# ***FINAL ENVIRONMENTAL IMPACT REPORT***

## ***Stephen S. Wise Middle School Relocation Project***

***ENV-2003-4563-EIR***

**THIS DOCUMENT COMPRISES THE SECOND AND FINAL PART OF THE ENVIRONMENTAL IMPACT REPORT (EIR) FOR THE PROJECT DESCRIBED. THE DRAFT EIR THAT WAS PREVIOUSLY CIRCULATED FOR PUBLIC REVIEW AND COMMENT COMPRISES THE FIRST PART.**

Figure 2  
Open Space Area Within  
Middle School Site

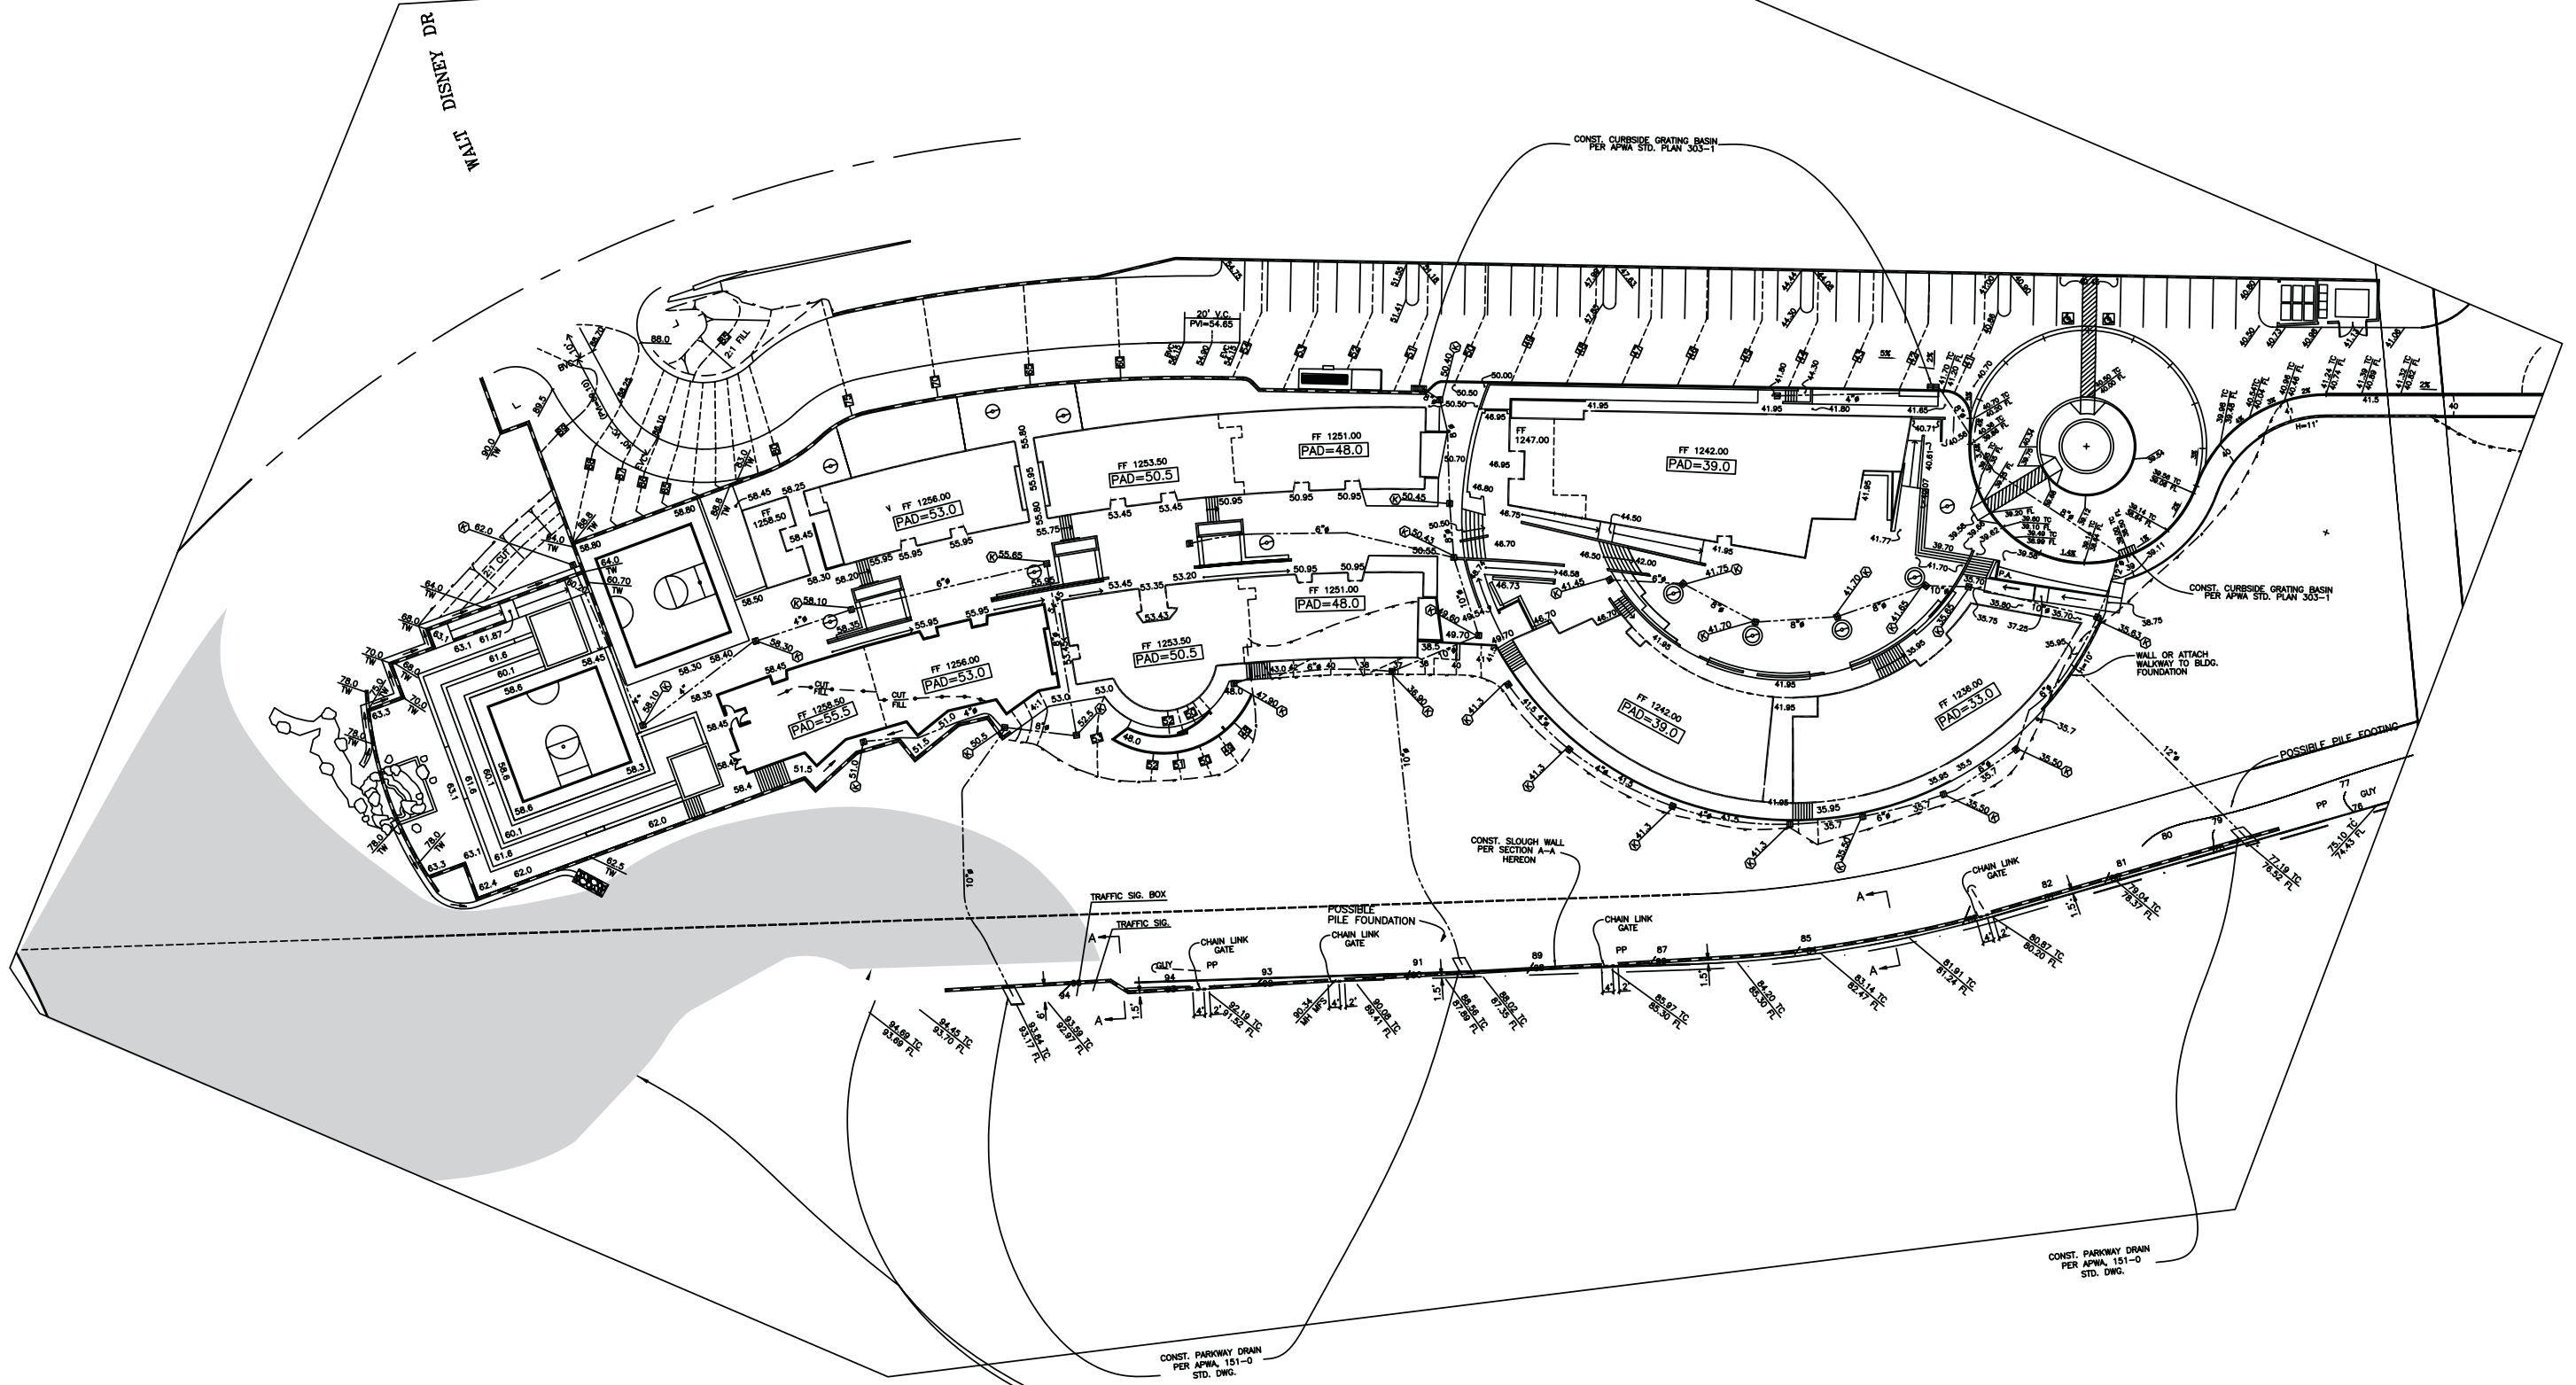
**COMMENT 4-15**

The following information is critical to a wildlife corridor analysis. Our NOP letter requested,

“To help the public and decision makers with understanding the area, the DEIR should include as many figures and maps as necessary to show the exact parcel boundaries of every property located in the aerial photograph labeled Figure A-3 in the distributed Environmental Assessment Form and Initial Study. These new figures must use the most up to date City of Los Angeles parcel data to be accurate. The figures should clearly label any property that is permanently protected by deed restriction, condition of approval, or public ownership. The

None of that information was included in the DEIR. The FEIR will remain deficient if it does not include this information. The school should provide permanent protection for all remaining open space, graded and ungraded. The school must disclose what real property is available or not available for such protection.

Please refer to Response to Comment Nos. 4-2 through 4-13 above. The information requested in the comment would be meaningful if a wildlife movement corridor did exist across the Mulholland Drive-405 Freeway crossing. However, based on the best information available and the Draft EIR’s supplemental analysis of aerial photography, and in the absence of any data suggesting such a corridor does exist, it is the Draft EIR’s conclusion that no such corridor exists, the project will not result in significant adverse impacts to wildlife movement, and no mitigation measures, including open space planning on site and in the immediate vicinity for the purpose of providing a movement corridor, are warranted. Moreover, the Draft EIR does include a number of figures and maps depicting the project site and surrounding area, including Figures 2 and 3 at pages 42 and 43, respectively. Figure 2 on page 62 of this Final EIR also shows where the northern portion of the project site will continue to be available for use by wildlife.
